# Review of the Shearon Harris Unit 1 Auxiliary Feedwater System Reliability Analysis

Prepared by  
A. Fresco, R. Youngblood, I.A. Papazoglou

Brookhaven National Laboratory

Prepared for  
U.S. Nuclear Regulatory  
Commission

Figure 1 Comparison of reliability of the SHNPP AFWS with that of other AFWS designs in plants using the Westinghouse NSS5.

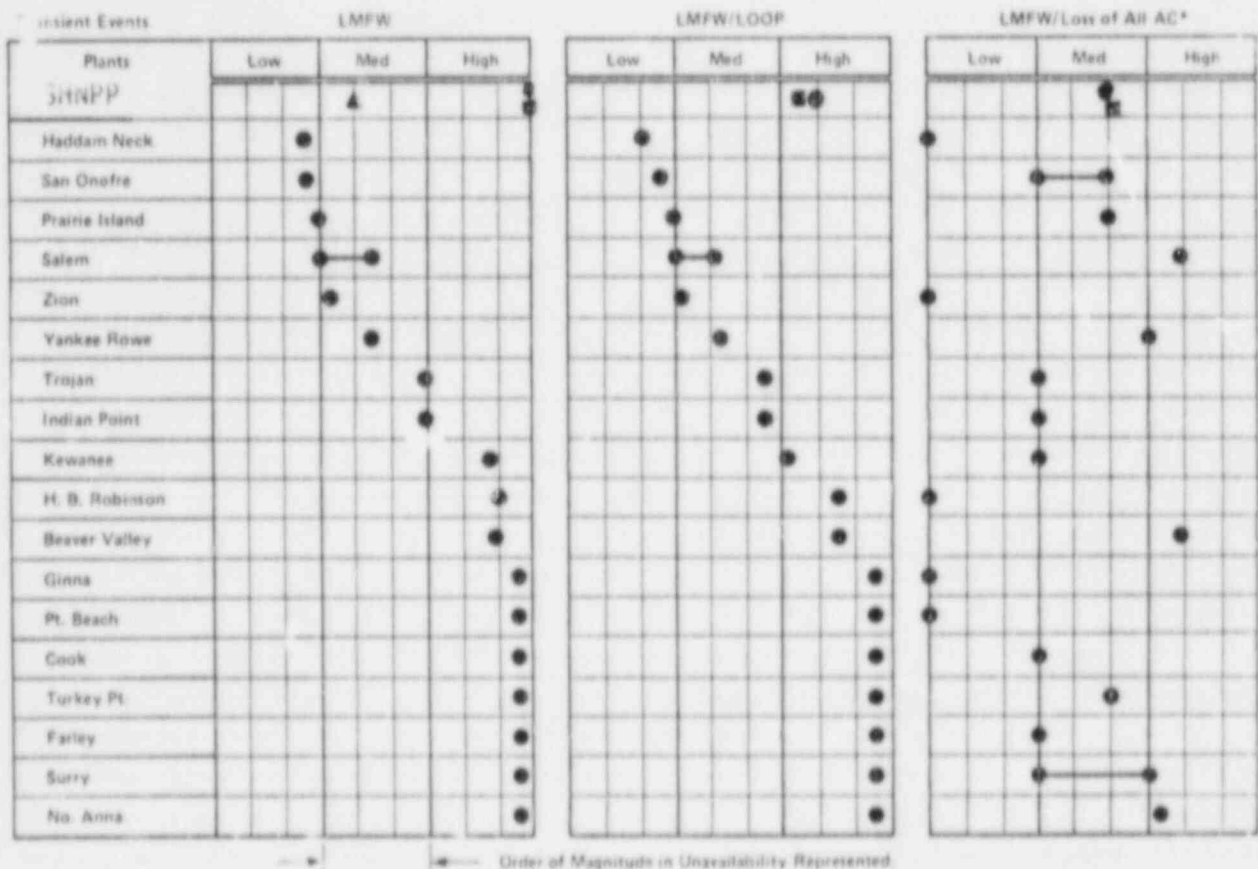
Results are summarized in Table 1. The SHNPP AFWS reliability is compared with that of other AFWS designs in Westinghouse plants in Figure 1.

FSAR FIGURE 10.4.9A-1: SHEARON HARRIS NUCLEAR POWER PLANT UNIT 1 AUXILIARY FEEDWATER SYSTEM AVAILABILITY STUDY SIMPLIFIED FLOW DIAGRAM

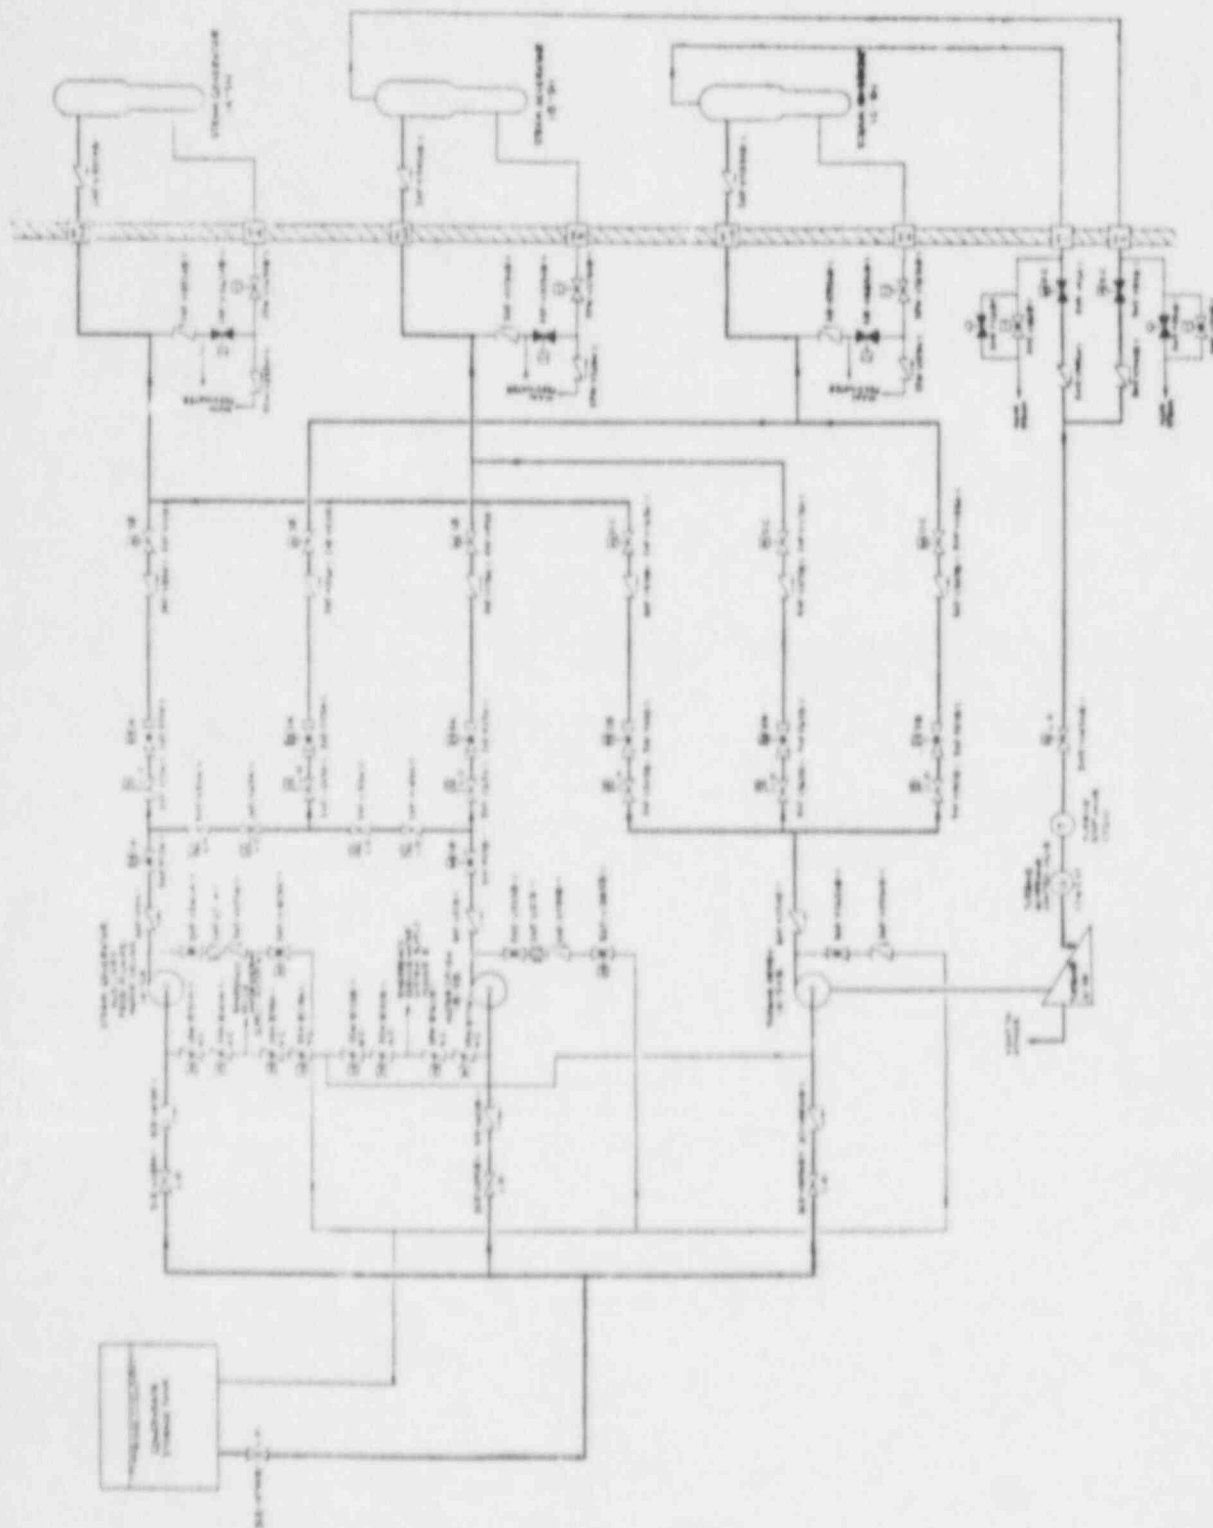
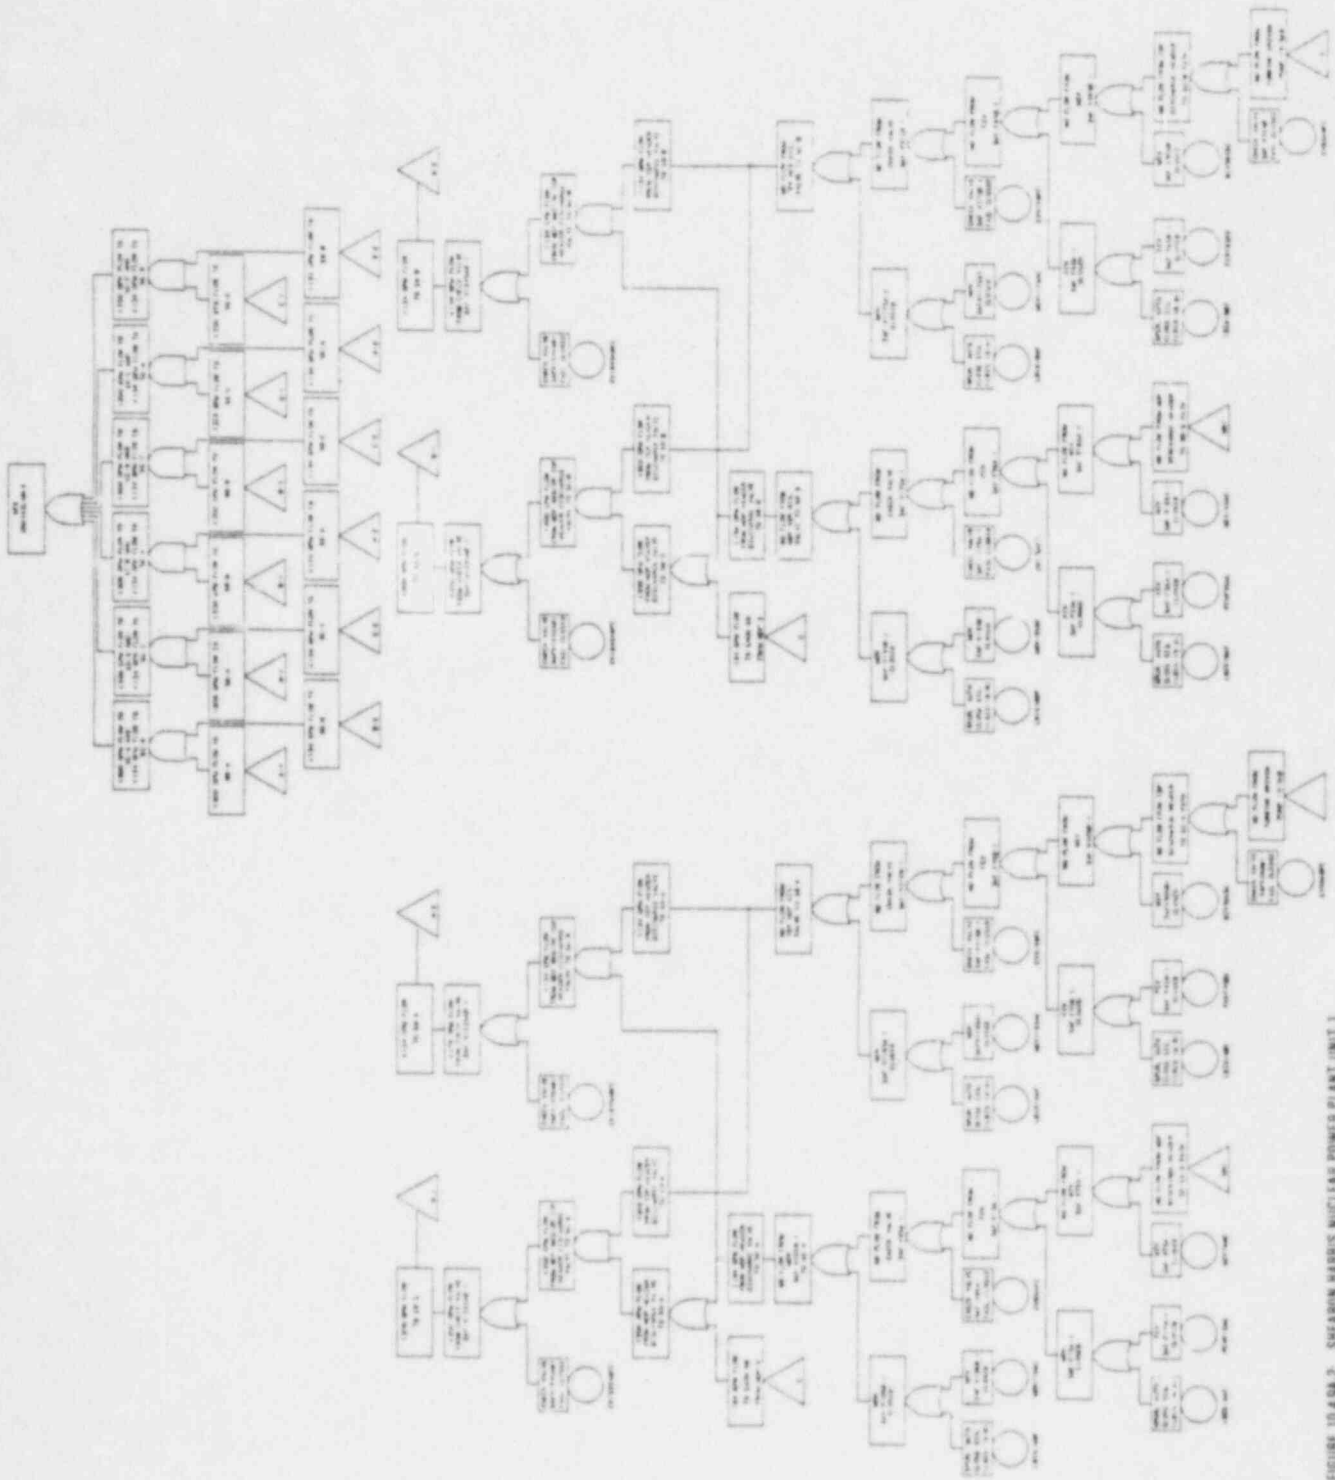
Although Ref. 3 states that system maintenance has no potential for causing common mode failures because plant procedures will prohibit maintenance which would simultaneously disable both system trains, the detailed application of this policy is not clearly identified. It is particularly obscure for the SHNPP system as evidenced by the location of both Train A and Train B valves on both the MDPs' common discharge header and the discharge header of the TDP (see Figure 10.4.9A-1). If maintenance of, for

example, MOV 2AF-V10SB-1 on the MDP line to SGA is required, there is no obvious reason not to allow maintenance on flow control valve 3AF-F1SA-1, even though each valve is on a different emergency bus.

Although not shown on the Simplified Flow Diagram, Figure 10.4.9A-1, safety-grade flowmeters with Control Room indication and instrument channels powered from emergency busses have been provided to indicate flow to each steam generator. This appears to satisfy the requirements of Additional Short-Term Recommendation 5.3.3 of NUREG-0611.

Therefore, as stated previously in Section 6, BNL has assumed that no test or maintenance acts will be performed which will simultaneously block all flow to any one steam generator or block flow from more than one pump.

Figure 4 SHNPP Auxiliary Feedwater System BNL Results - Dominant Cut sets - LOAC - Case 3 (Sheet 1 of 2)

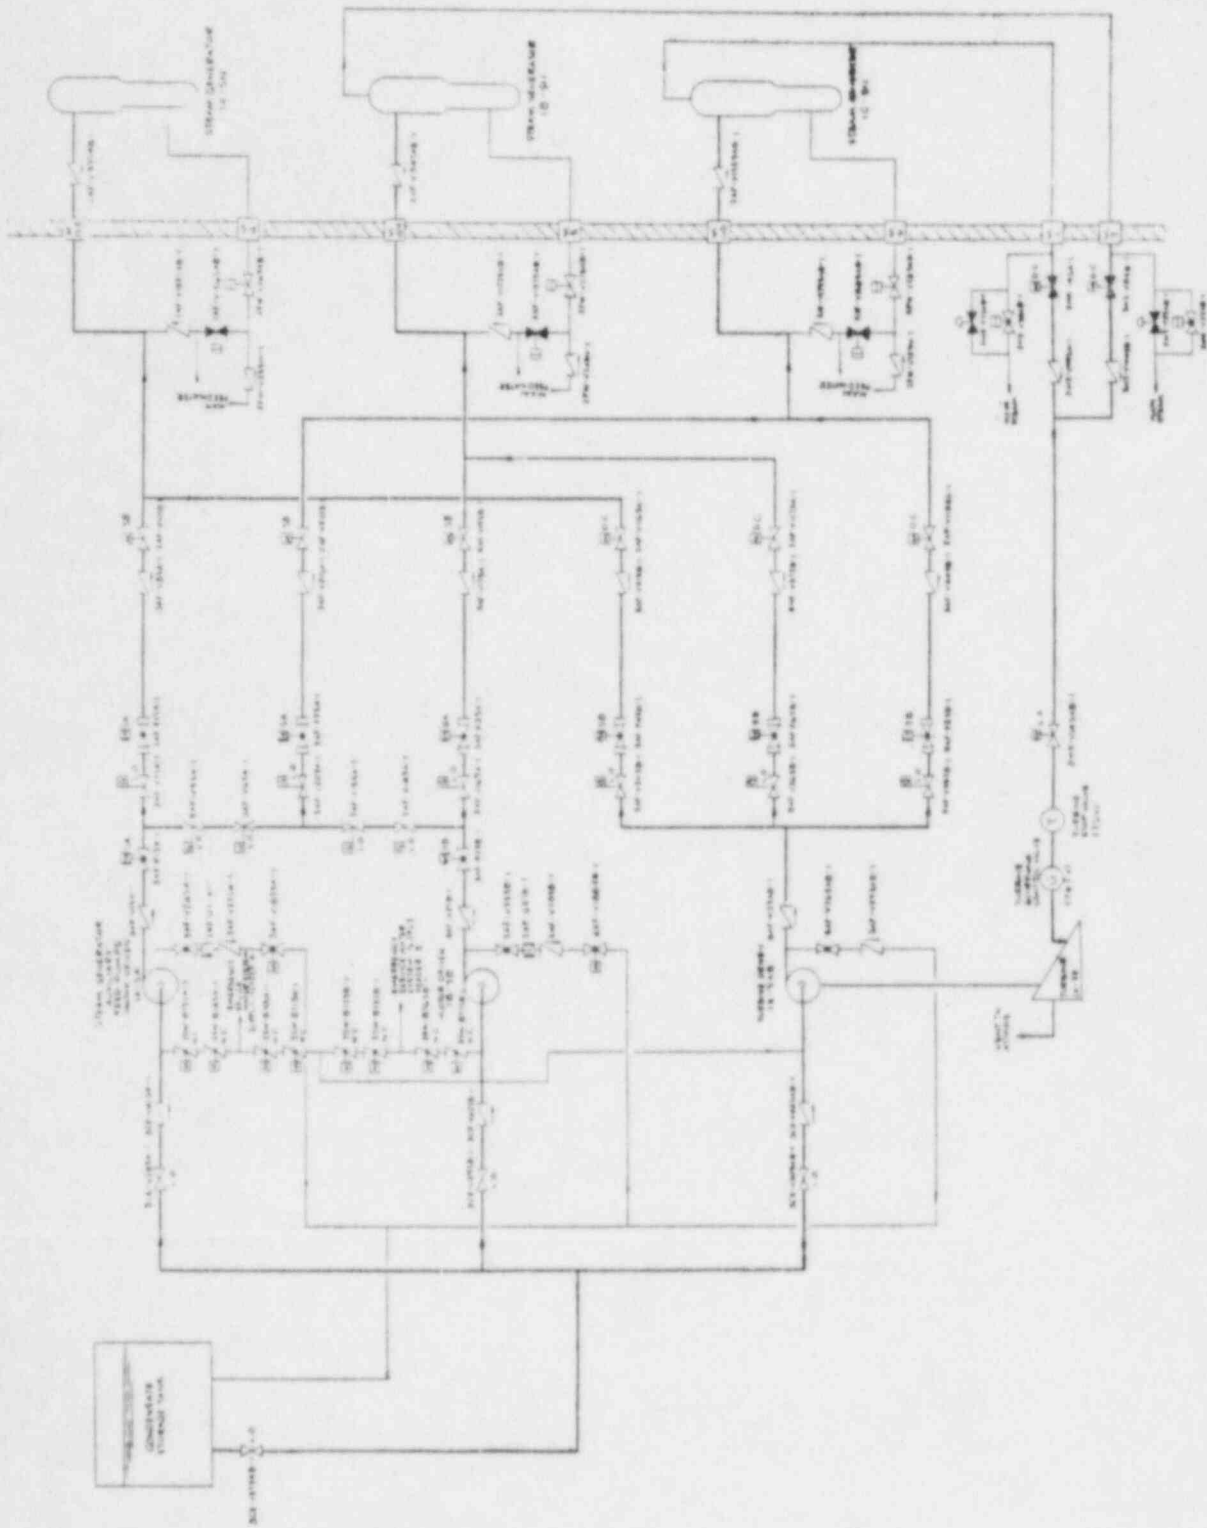
isolation valves in the pump suction line, maintenance on or component failures of the turbine stop valve or governing control valve, etc. (see Figure 4).
